<u>VDEO</u>	AFIN: 33-000 COUNTY: 33 GPS LAT: FACILITY INFORMATION Melbourne Spur Irne, AR RESPONSIBLE OFFICIAL AHalbrook / Mayor Melbourne RESS: AVERAGE AND	WATER I	DIVISION INSPECTION REPORT				
	ADLQ	AF	IN: 33-00026 PE	ERMIT #: AR002 0	0036		DATE: 1	1/26/2016
Δ	RKANSAS	CC	UNTY: 33 Izard		PDS #	#: 089189		MEDIA: WN
Dep	partment of Environmental Quality	GP	S LAT: LO	ONG: LOC	ATION	l: ******		
	FACILITY INFORMAT	ION		IN	SPECT	TION INFO	RMATIO	N
Cit	y of Melbourne			FACILITY TYPE: 1 - Municipal		or id#: 162 S - Stat	е	
	y 9 Spur			FACILITY EVALUATION RATING 2 - Marginal	2 - Marginal SSO/Collection Sy		ion System	
Ме	lbourne, AR			(-)	1:32	EXIT TIME: 12:45		FECTIVE DATE:
	AME: / TITLE			172072010	1.02	12.40	11/1/2 PERMIT EX	(U15 (PIRATION DATE:
	IAME: / TITLE					10/31	/2020	
COM				FAYETTEVILLE SHALE RELATED: N				
Cit	y of Melbourne			FAYETTEVILLE SHALE VIOLATIONS: N				
MAILING ADDRESS:		INSPECTION PARTICIPANTS

Re: Response to City of Melbourne Inspection (Izard Co)

AFIN: 33-00026 NPDES Permit No.: AR0020036

Figure 1. Aerial view of WWTP location and the four (4) lift stations associated with the collection system (Google Earth: imagery date November 16, 2012).

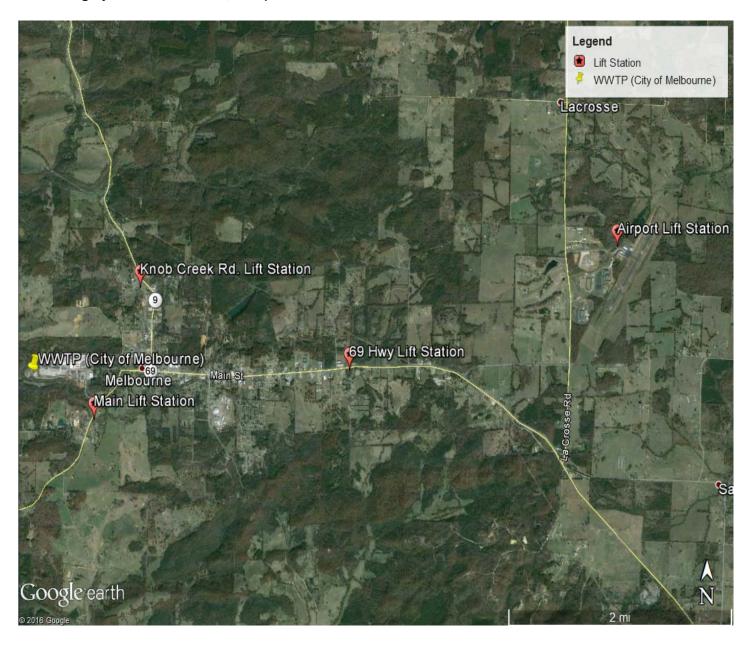
An inspection on the City of Melbourne's collection system was conducted on Tuesday, January 26, 2016 with the above-mentioned inspection participants. All four (4) of the City's lift stations were evaluated during the inspection. The system consists of gravity flow service lines to the WWTP and includes a force main system with four (4) pump/lift stations. The Main Lift Station is the only station that receives industrial wastewater according to the operator.
